6436 W. Hollywood Blvd
DOT Case No. CEN 16-44677

Subject: **TRANSPORTATION IMPACT ASSESSMENT FOR THE PROPOSED
MIXED-USE DEVELOPMENT PROJECT LOCATED AT 6436 WEST
HOLLYWOOD BOULEVARD**

The Department of Transportation (DOT) has reviewed the traffic impact analysis, dated January 2018 prepared by Gibson Transportation Consulting Inc., for the proposed mixed-use development located at 6430-6436 West Hollywood Boulevard and 1624-1648 Wilcox Avenue. In order to evaluate the effects of the project's traffic on the available transportation infrastructure, the significance of the project's traffic impacts is measured in terms of change to the volume-to-capacity (V/C) ratio between the "future no project" and the "future with project" scenarios. This change in the V/C ratio is compared to established threshold standards to assess the project-related traffic impacts. Based on DOT's traffic impact criteria¹, the traffic study included the detailed analysis of 22 intersections, including 19 signalized and three unsignalized and determined that the project-related traffic would significantly impact one of the study signalized intersections as summarized in **Attachment 1**. The results of the

FIGURE
1

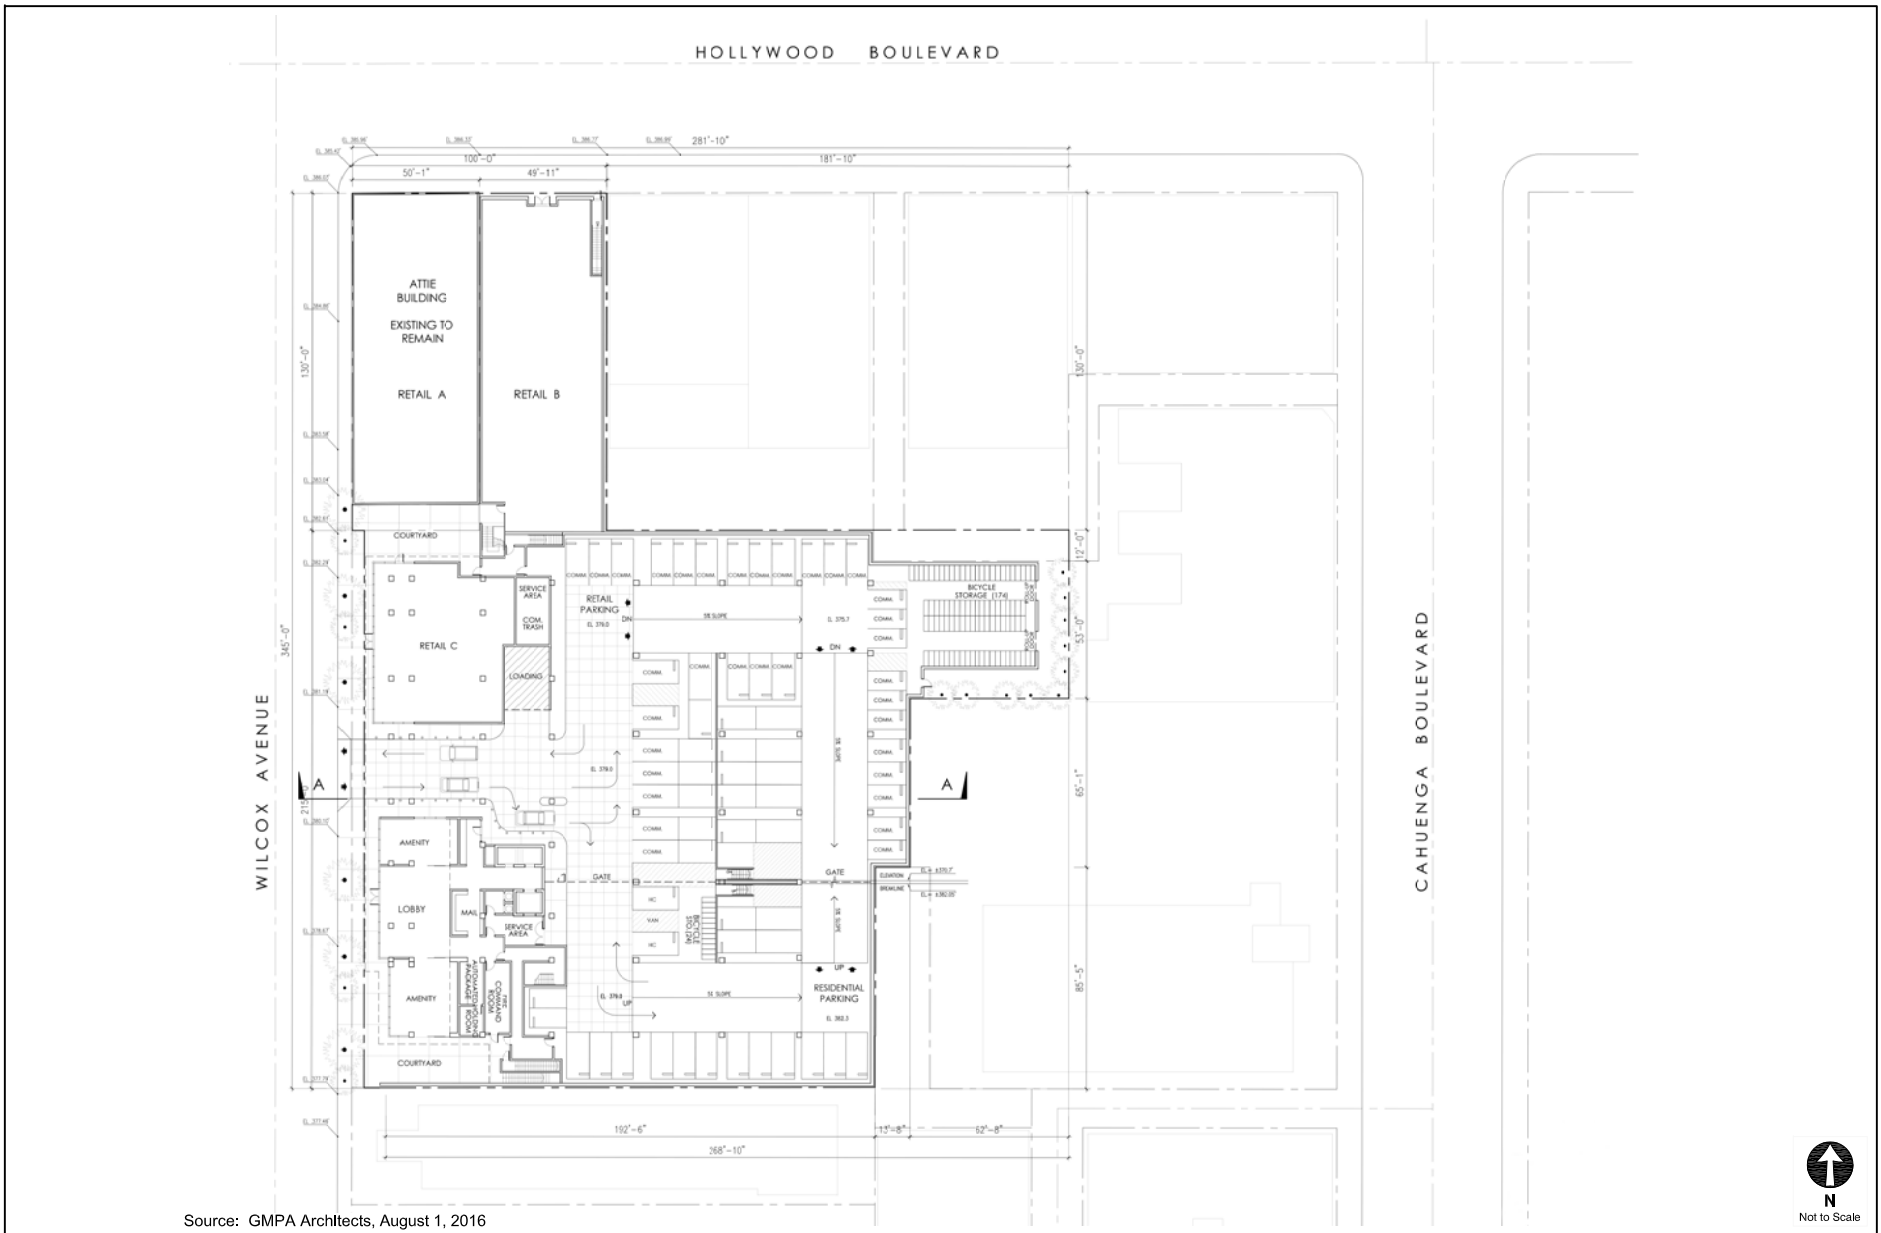
The proposed site plan illustrated in **Attachment 4** is acceptable to DOT; however, review of the study does not constitute approval of internal circulation schemes and driveway dimensions. Those require separate review and approval and should be coordinated with DOT's Citywide Planning Coordination Section (201 N. Figueroa Street, 5th Floor, Station 3, @ 213-482-7024). In order to minimize and prevent last minute building design changes, the applicant should contact DOT, prior to the commencement of building or parking layout design efforts, for driveway width and internal circulation requirements. Any changes to the project's site access, circulation scheme, or loading/unloading area after issuance of this report would require separate review and approval and should be coordinated as well.
